**SITE NUMBER: 4BS0539A**  
**SITE NAME: BS539/CEDAR STREET WT-RFP**

396 CEDAR STREET  
 ASHLAND, MA 01721  
 MIDDLESEX COUNTY

Text in red outlined boxes are Haley Ward, Inc comments under peer review #1. See letter dated 11.7.2023

**EXISTING & PROPOSED ANTENNA PLAN**

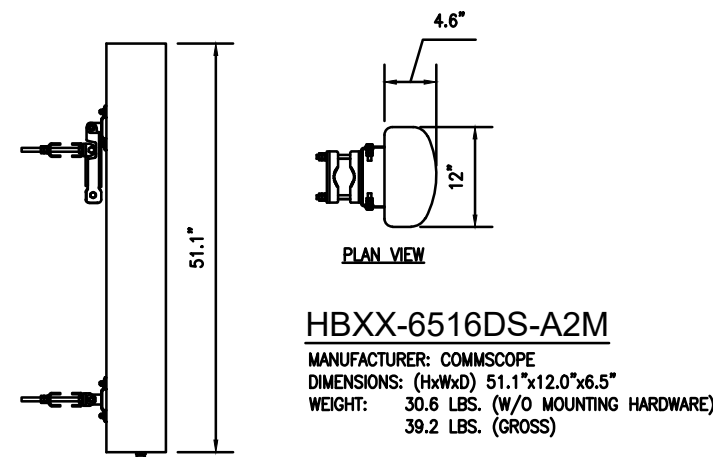
Appears to have 2 antenna on this mast, sector A only? Provide details elevation of this mast

4 TANK-MOUNTED CABLE TRAY W/ STAND-OFF  
 A-5 SCALE: N.T.S.

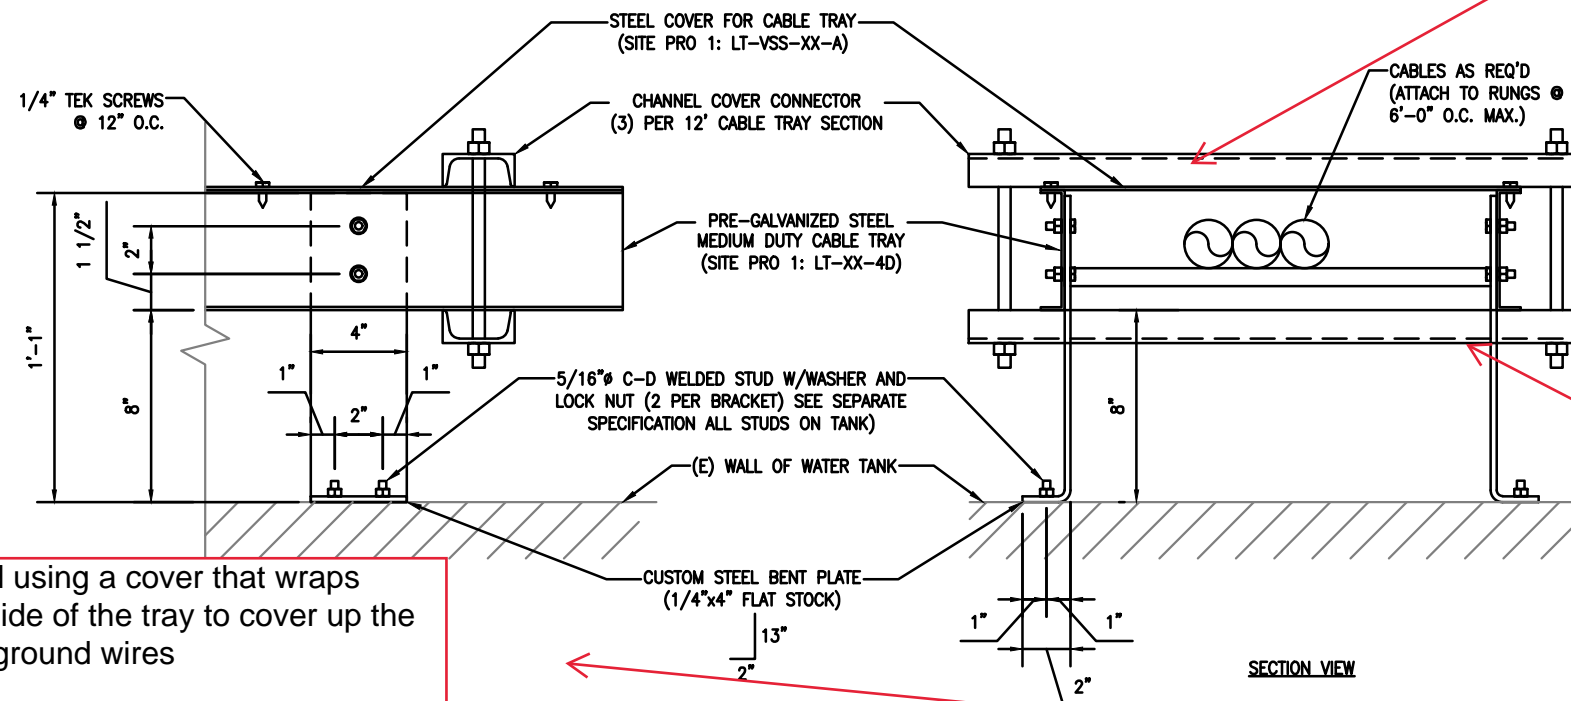
provide additional details on this type of cover anchor system

Recommend using a cover that wraps around the side of the tray to cover up the splices and ground wires

Recommend back plate to protect cables during tank coating system replacement

Requesting consideration of adding a 3rd stud weld here

1 ANTENNA/RRU MOUNT DETAIL  
S-1 SCALE: 1/2" = 1'-0"  
0 1'-0" 2'-0" 4'-0"

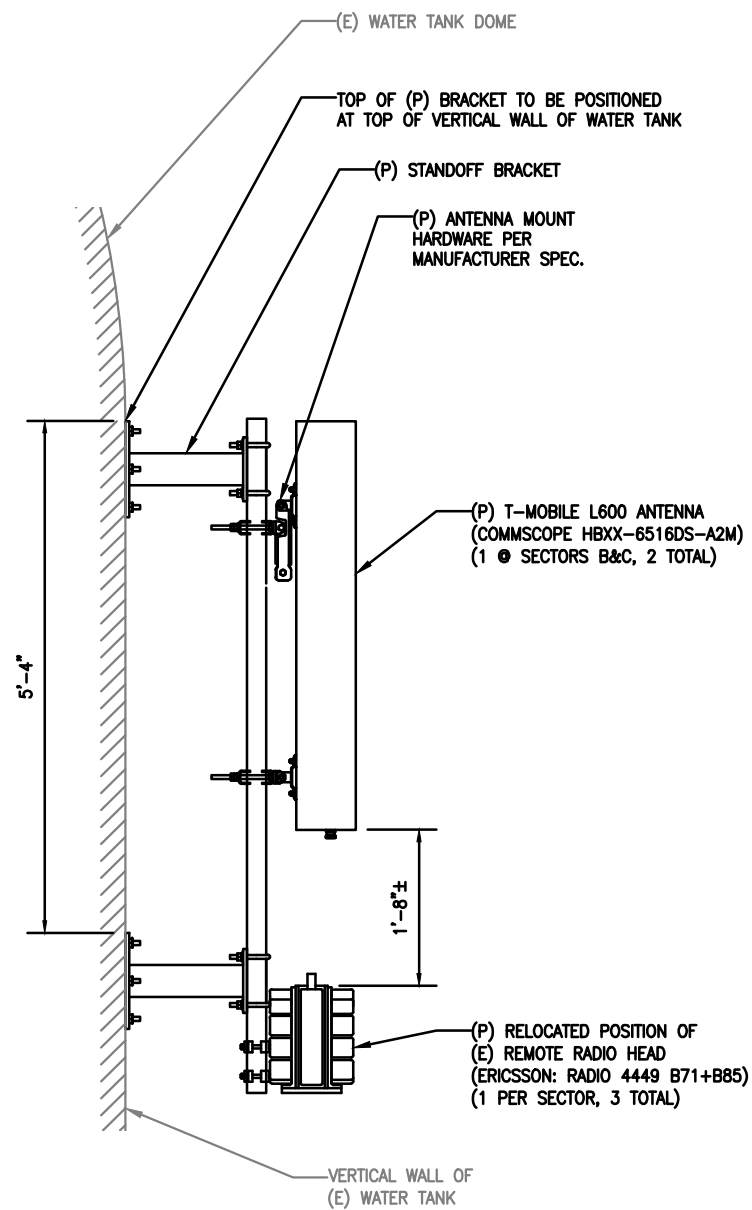
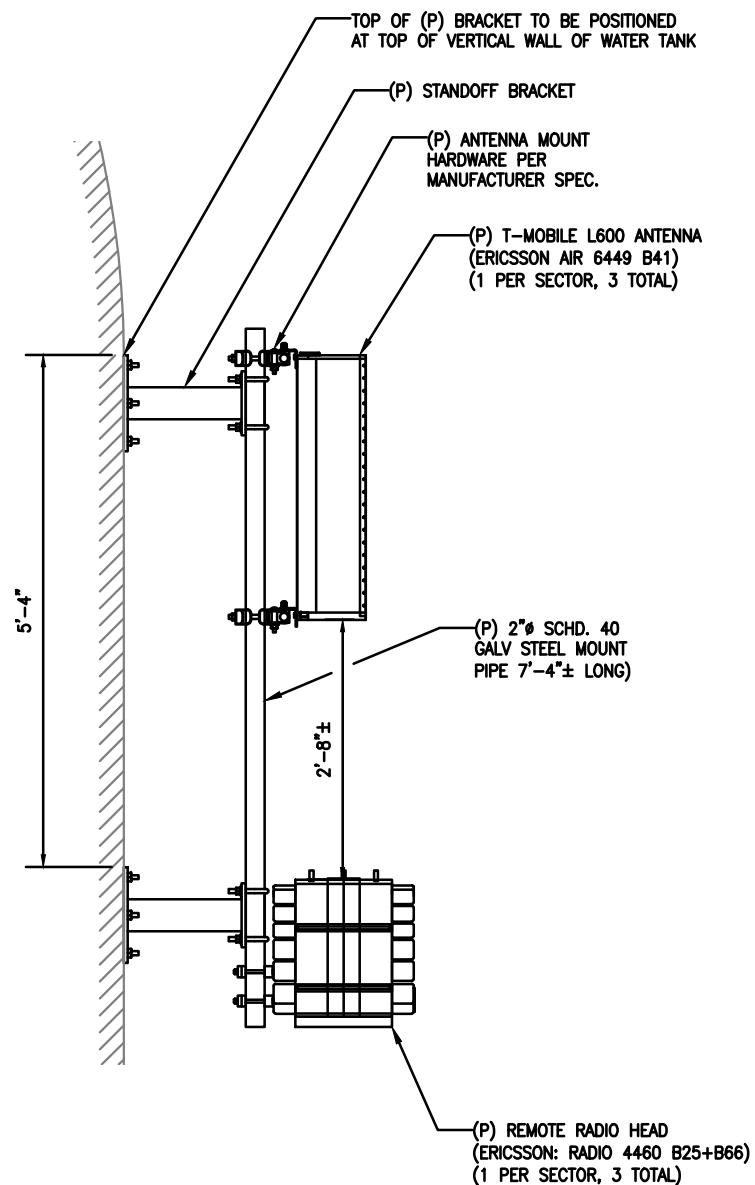
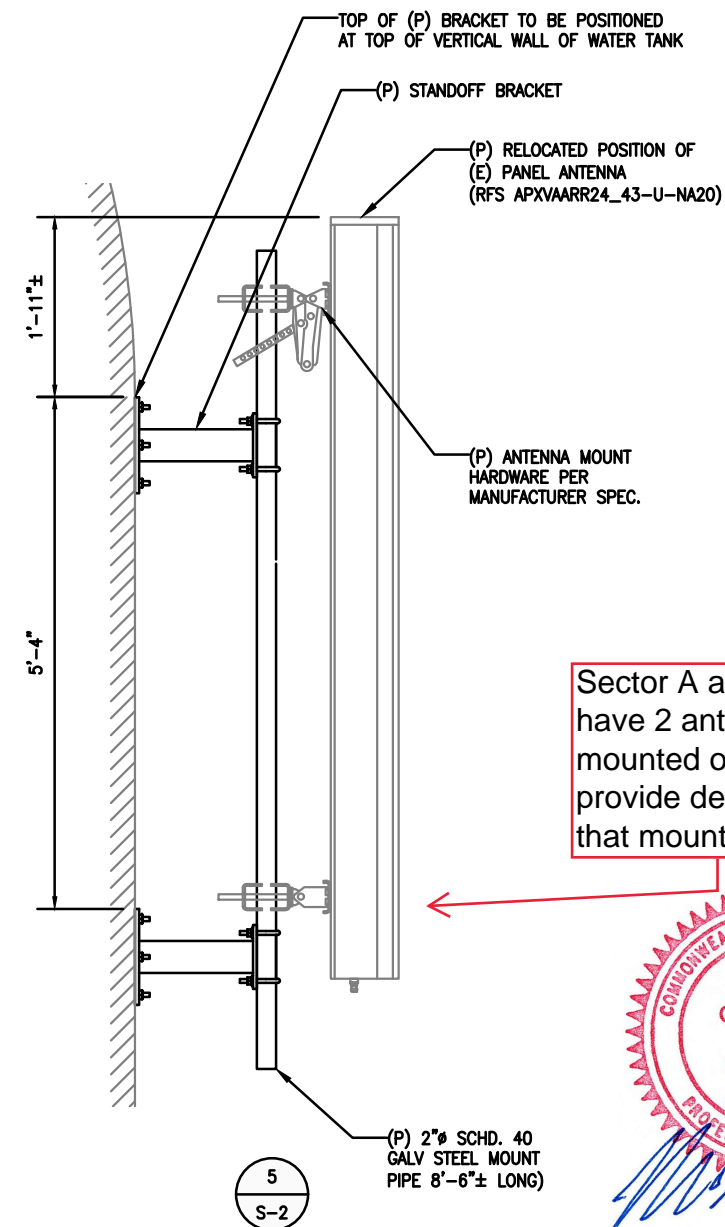
Sector A appears to have 2 antenna mounted on 1 pole, provide detail of that mounting

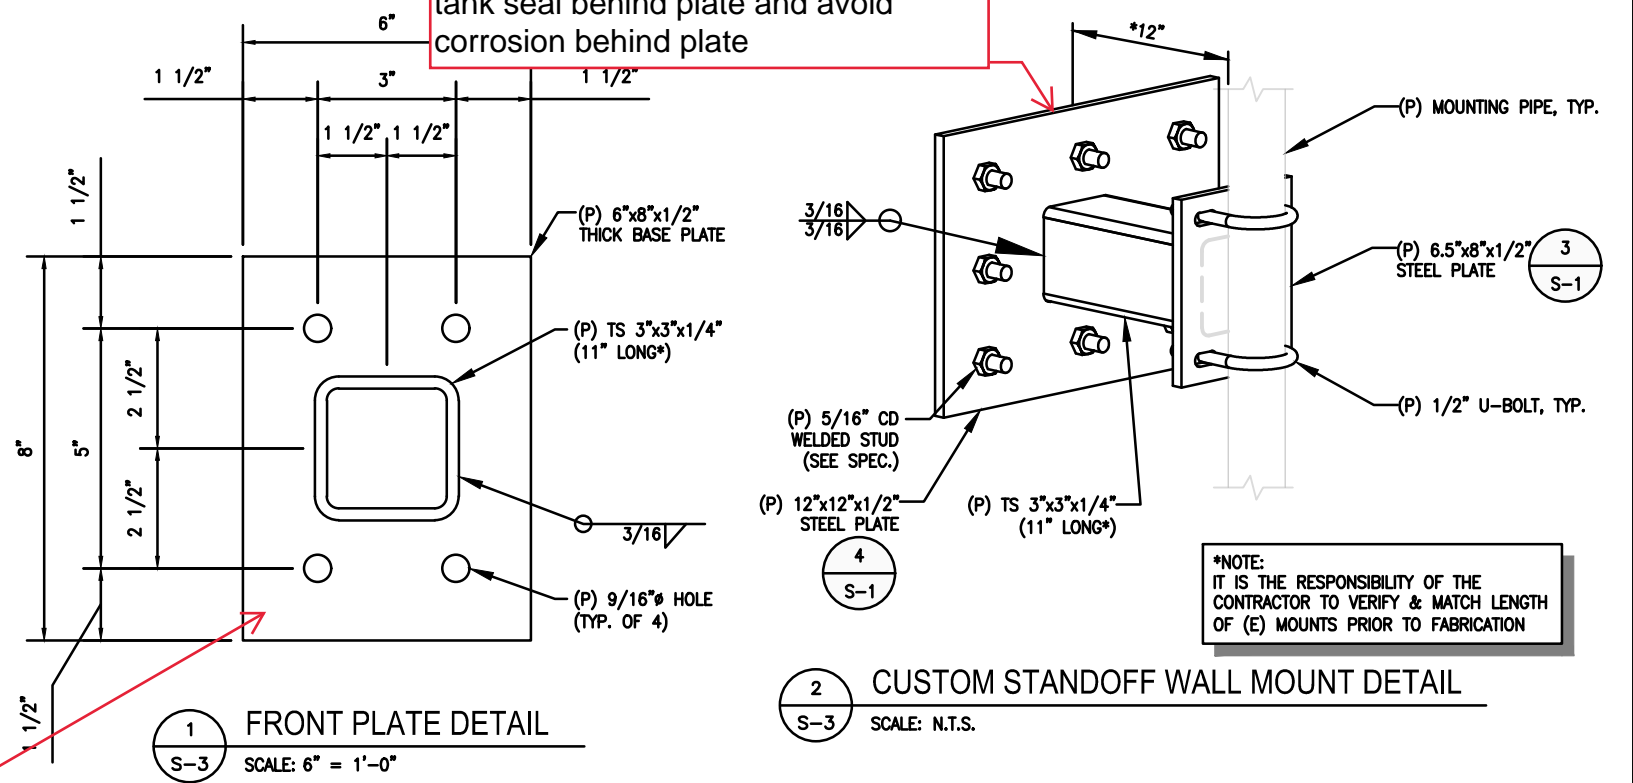
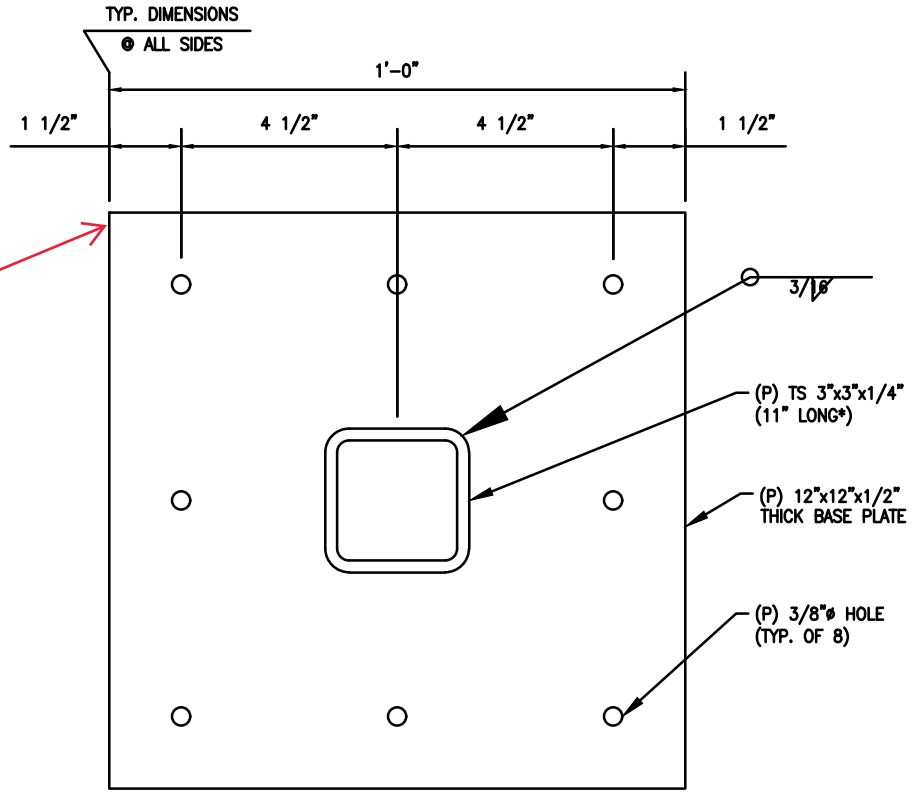
Add sealant between steel plate and tank seal behind plate and avoid corrosion behind plate

Round edges of steel plate to accept coating system

Round edges of steel plate to accept coating system
